Preliminary Plan Extension

Forest Lake Estates

Liverpool Township

Meeting:	June 5, 2024	**Sublots:**	32 Sublots
App. No.:	026-2024 PP Ext	**Zoning:**	R-R Rural Residential District
Applicant:	Artisan Bldg and Design		CDZ Controlled Density
Surveyor:	Rolling & Hocevar		Zoning, Overlay District
Developer:	Artisan Bldg and Design	**Utilities:**	Central Water and Sewer
Parcel:	025-01D-32-018	**School:**	Buckeye Local
Site Area:	38.6365 acres	**Reviewer:**	Denise Testa

PRELIMINARY PLAN for

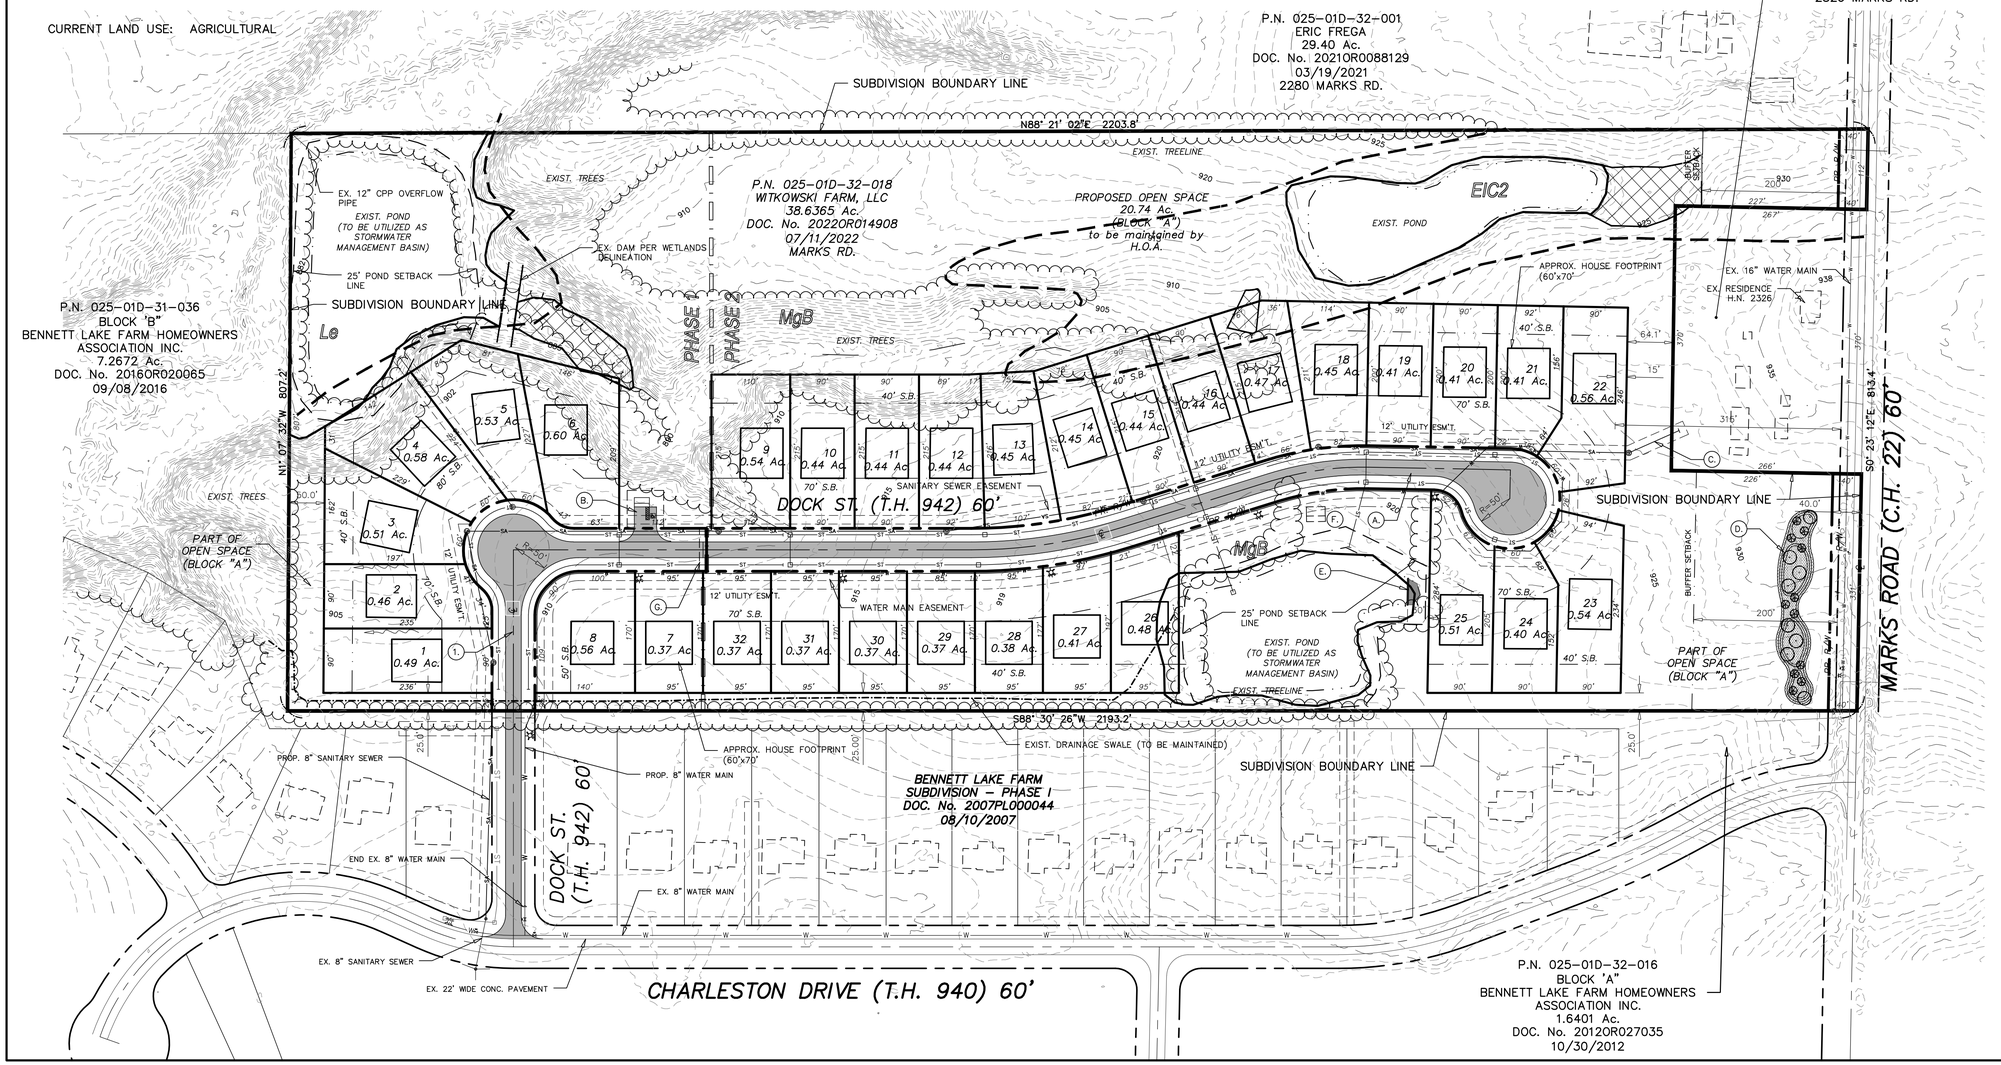
The water main should connect from Dock St to Marks Rd through an easement in the open space between S/L 22 & S/L 23. The proposed sanitary easement for the 4" sanitary lateral for H.N. 2326 Marks Road shall be a private easement between the HOA and property owner of 2326 Marks Road. Detailed engineering plans at the time of construction must meet the current Rules and Regulations for water and sanitary sewer per the Medina County Sanitary Engineer.

1. *Frontage improvements to be completed along Marks Road frontage of subdivision open space.*
2. *Sublots 4, 6, 11, 12 & 17 have limited building envelopes with potential for future slope stability issues that will be inherited by the property owners.*

3. *The building envelope for sublot 26 is within the existing pond area.*
4. *Grading for the mounding shown along Marks Road to be included on the subdivision grading plan.*

5. *Maintain existing watersheds – to be evaluated with construction drawing review.*
6. *Provide/show overland flood routes with the subdivision design.*

7. *Rear yard drainage conveyance to be addressed with subdivision design.*
8. *The outlet structures of the 3 existing ponds to be evaluated for future use.*

9. *The outlet for the stormwater management basin located between sublots 25 & 26 is to be designed to not cause negative impacts on the lots in the Bennett Lake Farm Subdivision.*

10. *Drainage maintenance fund required.*
11. *Stormwater management basins to be included in easements that are cleared of trees and accessible from the street.*
